Meadow Springs Pump Station Wells No. 1 and No. 2 RFCSP
Solicitation Number: CO-00637
Job No.: 22-6025

ADDENDUM 2
July 11, 2023

PLAT NO.	N/A
JOB NO.	11650-00
DATE	MARCH 2023
DESIGNER	RG
CHECKED LN	DRAWN AL
SHEET	C6.01

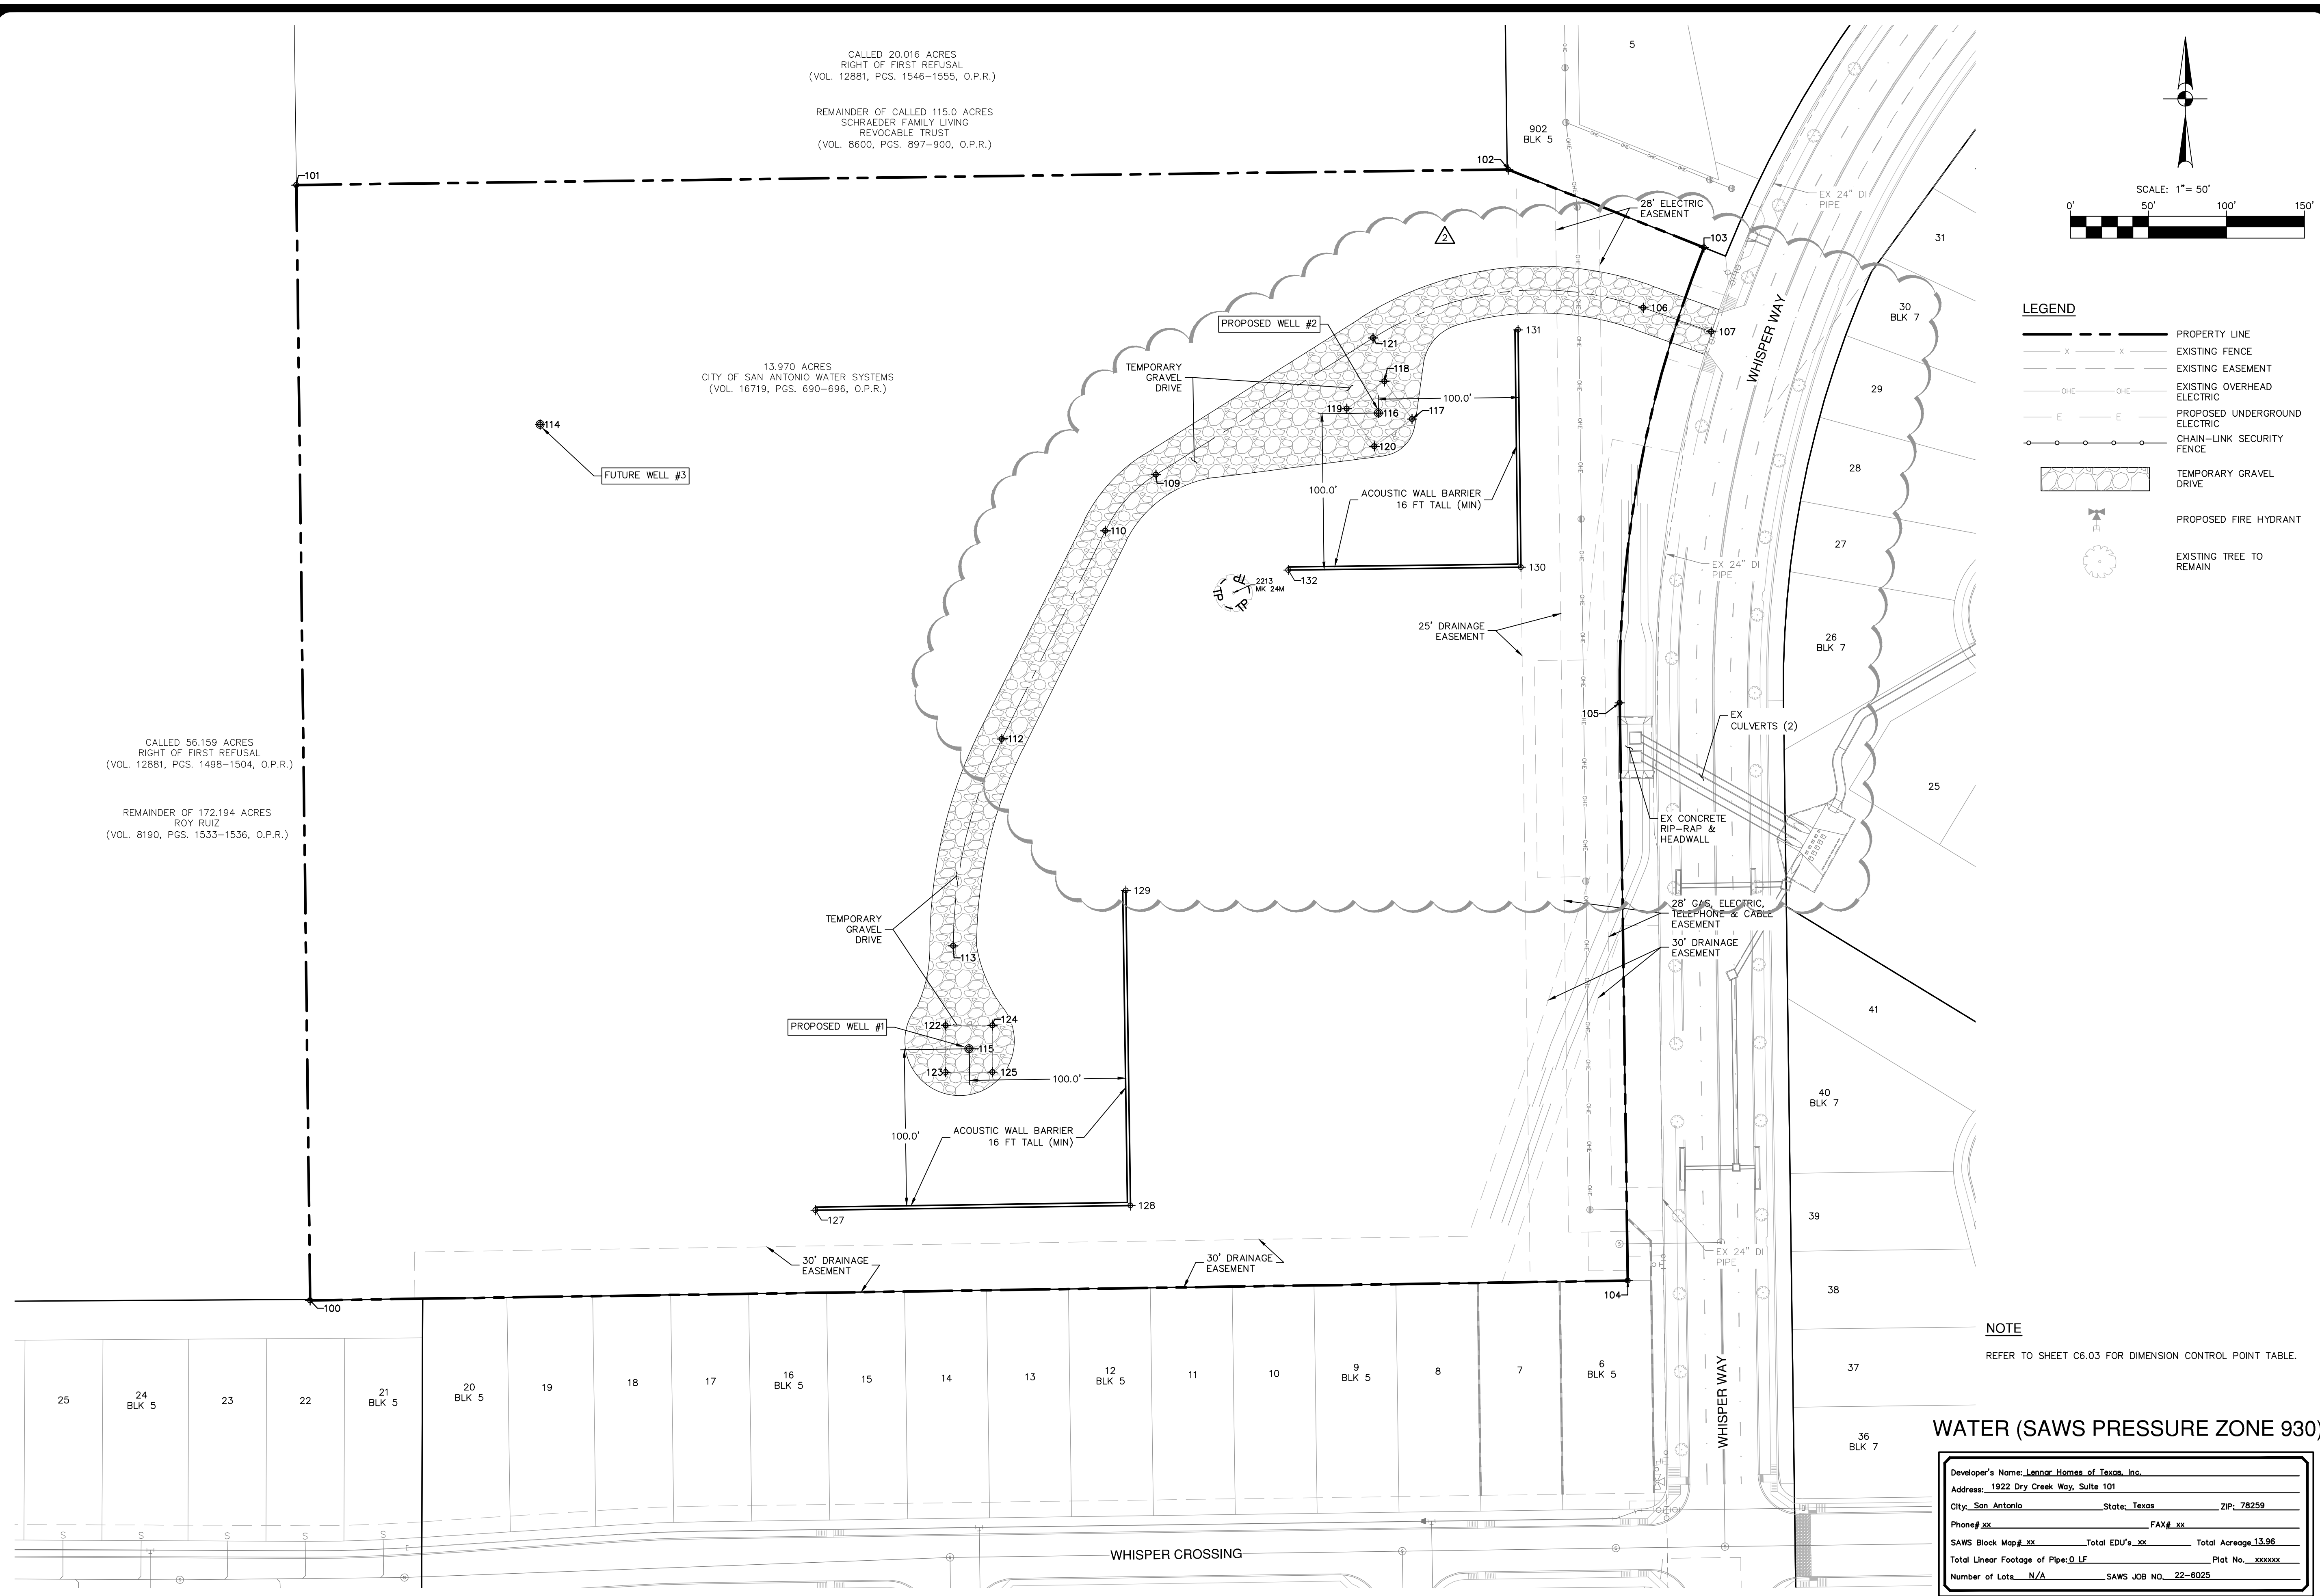
5. Can the location of the project access road be changed to the existing driveway cut?
Response: Yes, see revised drawings C2.01, C2.02, C3.01, C4.01, C6.01, and C6.02 attached to this Addendum.

6. C6.01 Add Addendum #2 – revised entrance location and gravel drive alignment. Remove Sheet C6.01 in its entirety and replace with the Revised Sheet attached to this Addendum.
7. C6.02 Add Addendum #2 – revised entrance location Remove Sheet C6.02 in its entirety and replace with the Revised Sheet attached to this Addendum.
8. C7.02 Add Addendum #2 – revise fence detail description Remove Sheet C7.02 in its entirety and replace with the Revised Sheet attached to this Addendum.
9. C7.03 Addendum #2 - Add this sheet to project drawings. Add Sheet C7.03 attached to this Addendum.

PLAT NO.	N/A
JOB NO.	11650-00
DATE	MARCH 2023
DESIGNER	RG
CHECKED	LN
DRAWN	AL
SHEET	C7.02

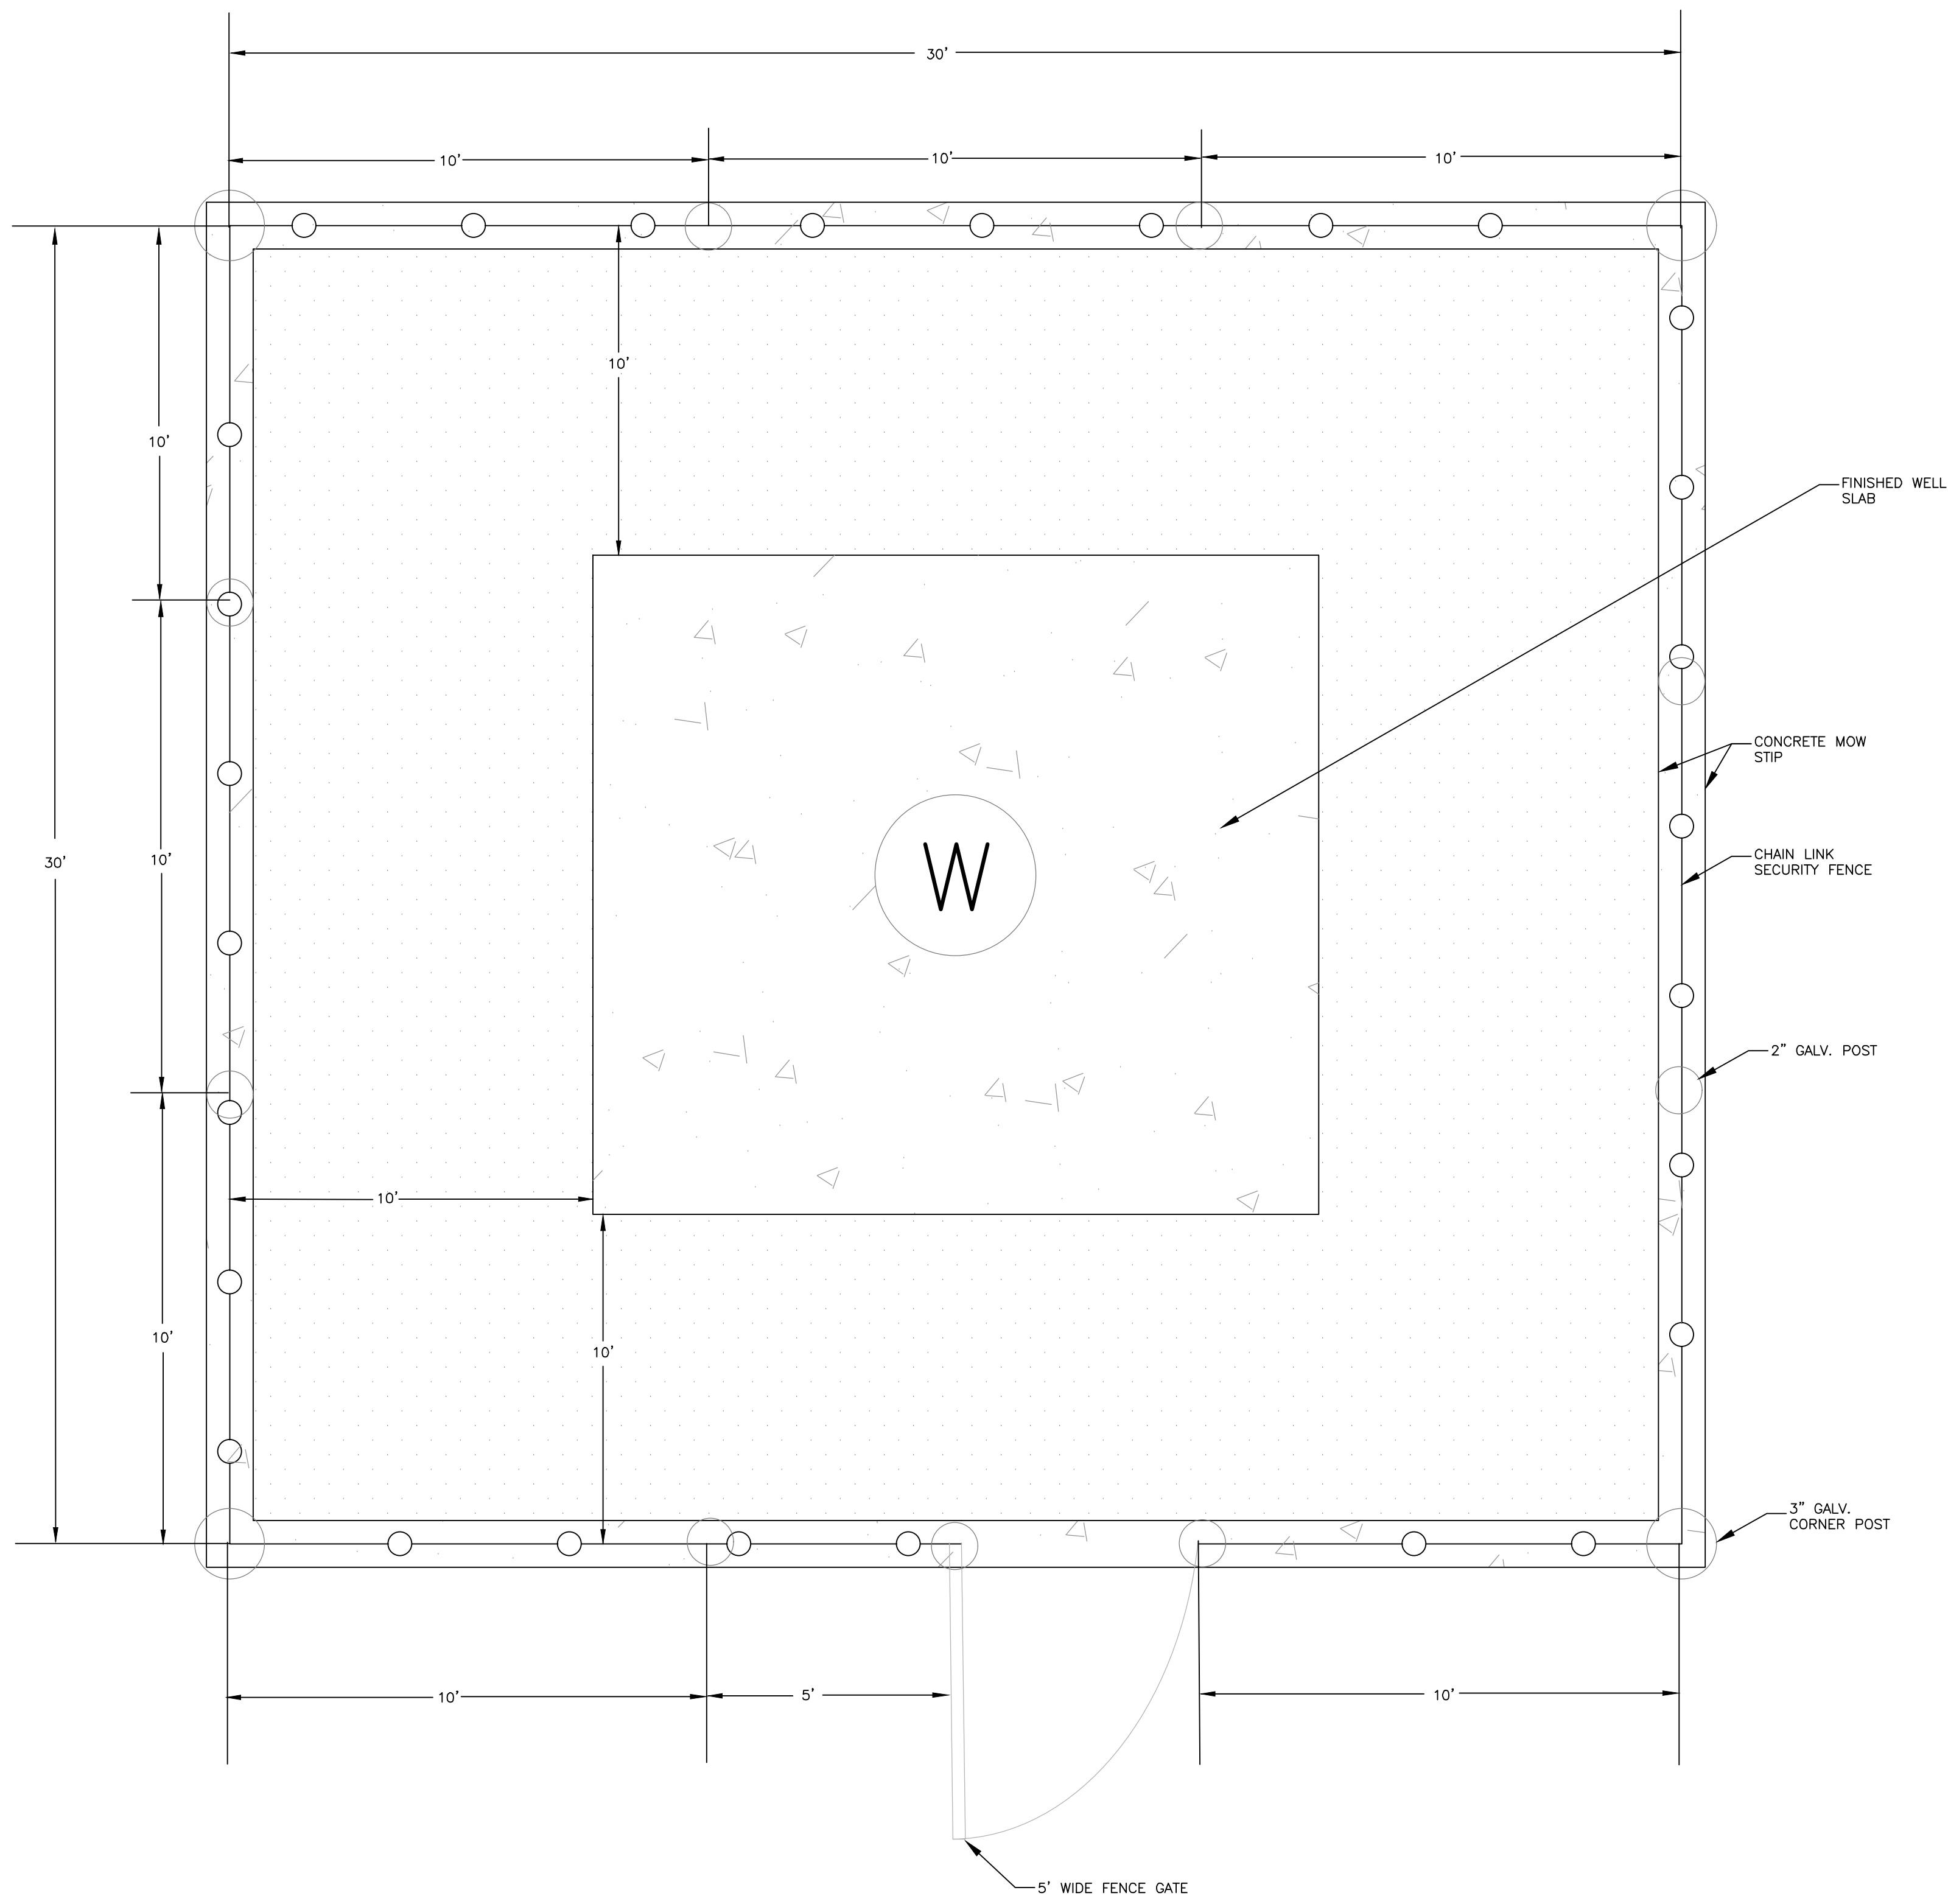
19. Specs state both 6' and 8' tall chain link fence.

Response: Security fence shall be 8' tall chain link per SAWS standards. Top of the fence shall have 3-strand barbed wires per SAWS standard details. Refer to revised sheet C7.02 attached to this Addendum.

- CONTRACTOR TO PROVIDE CHAIN LINK SECURITY FENCE AS SHOWN ON DRAWING. CONTRACTOR SHALL REFER TO SAWS WEBSITE ([HTTPS://APPS.SAWS.ORG/BUSINESS_CENTER/SPECS/CONSTSPECS](https://apps.saws.org/business_center/specs/constspecs)) FOR CURRENT STANDARD DETAILS FOR CONSTRUCTION (FENCE DETAILS SAWS 845).
- FENCE SHALL BE 8' TALL, WITH DUAL SETS OF 3-STRAND BARBED WIRE AT TOP OF FENCE.
